To: Mayor and Council
From: Katie Sickles
Date: April 16, 2025
Agenda Item: Taylor Street Reconstruction/Paving Drainage Alternative

Taylor Street Reconstruction/Paving Drainage Alternative Discussion and Direction

Re: Taylor Avenue Reconstruction -
Design Criteria Recommendations
Project No. 24-0060

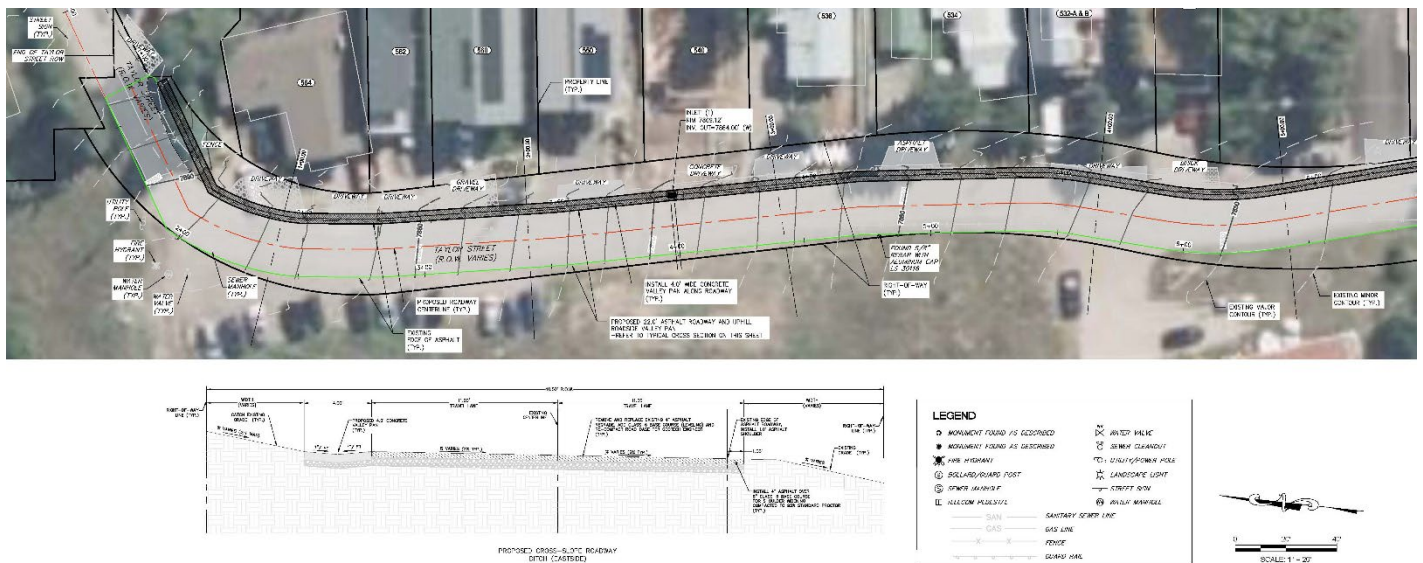
Controlling a major storm to address Council direction would require an identical ditch to that provided by Minturn North. A ditch that large will not fit within the Taylor Avenue right-of-way. The first set of drawings attached to this report is a conceptual design that includes a 6 foot wide, 14 inch deep ditch along the east side of Taylor. This ditch will contain the minor storm event,

allowing only a major storm event to flow across the roadway. Even with the roadway pushed to the west, this ditch will require steep driveway aprons, nearly 1,000 feet of driveway culverts and grading extending into private property. Existing natural gas, sanitary sewer, communication, and overhead electric distribution lines are located within the easterly side of the right-of-way and will require relocation. There are also private improvements including retaining walls and parking areas located within the right of way that will need to be removed or reconstructed.

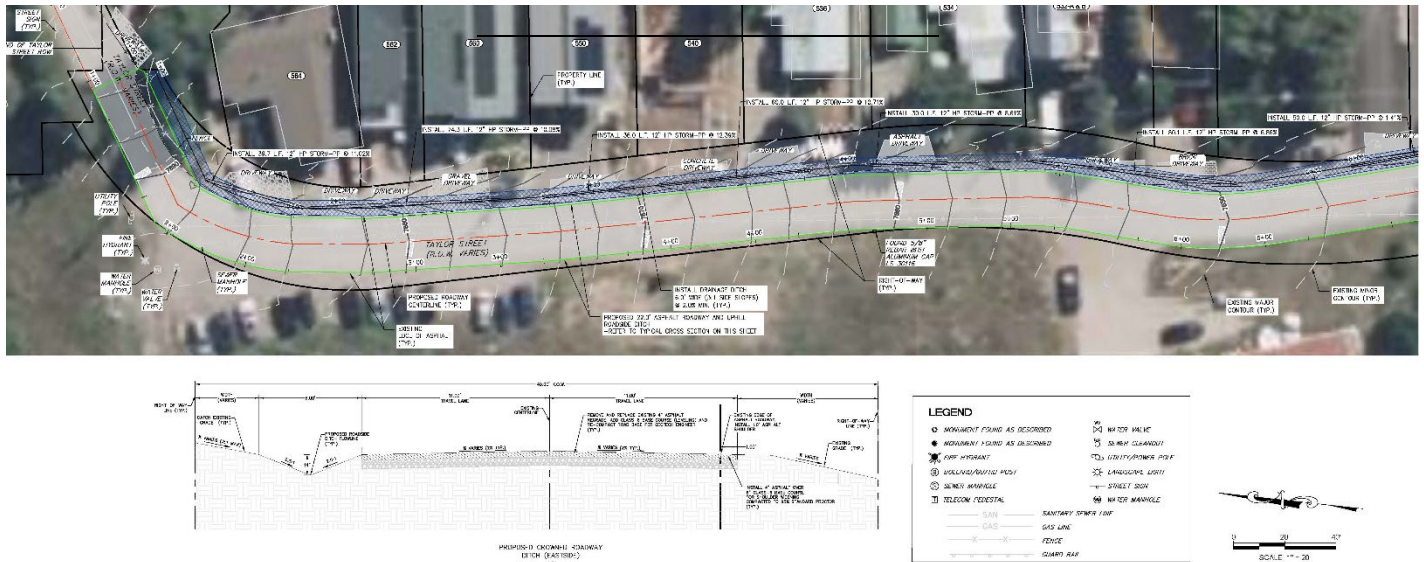
The least impactful alternative would be to replace Taylor Avenue with a properly constructed roadway. Sloping the road to the west provides the best way to match existing grades on the east side of the roadway. A 4 foot wide concrete pan on the east side of the roadway would capture nuisance flows from snowmelt and minor storm events. Catch basins located in the pan would intercept and direct drainage across the road to the Minturn North Drainage system. Speed dips can be incorporated to provide both traffic calming and additional drainage collection points. Large culverts would be installed at identified points of concentrated flow. A conceptual plan has been developed and attached for this alternative.

We recommend the Council consider the alternative including a 4 foot wide concrete pan with the roadway sloped to the west for the Taylor Avenue reconstruction.

Drainage ditch in Grant Avenue:

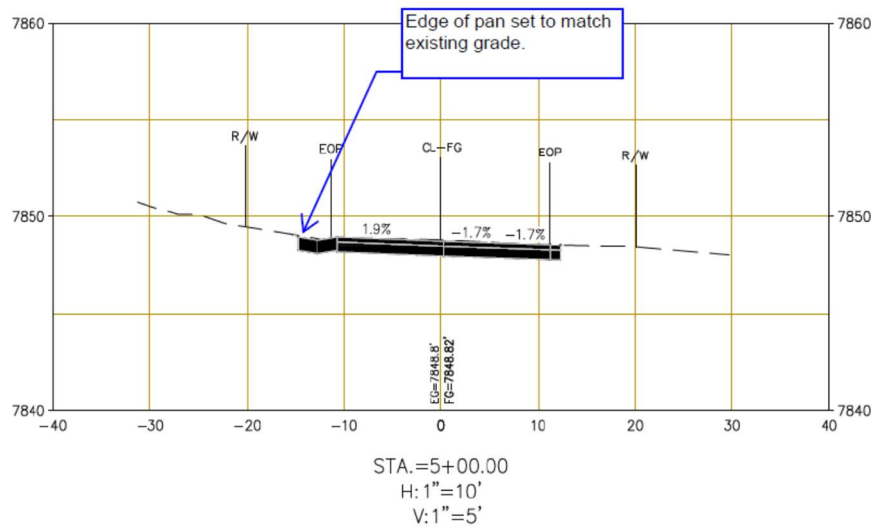
We were asked if it would be feasible to intercept drainage above the homes on Taylor Avenue by constructing a ditch within the Grant Avenue right-of-way. The following GIS photograph shows improvements that have been constructed within the Grant Avenue right-of-way. The Eagle County website identifies the photograph as approximately 20 years old, so it is likely additional obstructions exist. There is no direct access to Grant Avenue and physical access would be difficult. Access and drainage easements through the existing property between Taylor Avenue and Grant Avenue will need to be acquired. We could study further, but locating drainage facilities in Grant Avenue does not appear feasible.
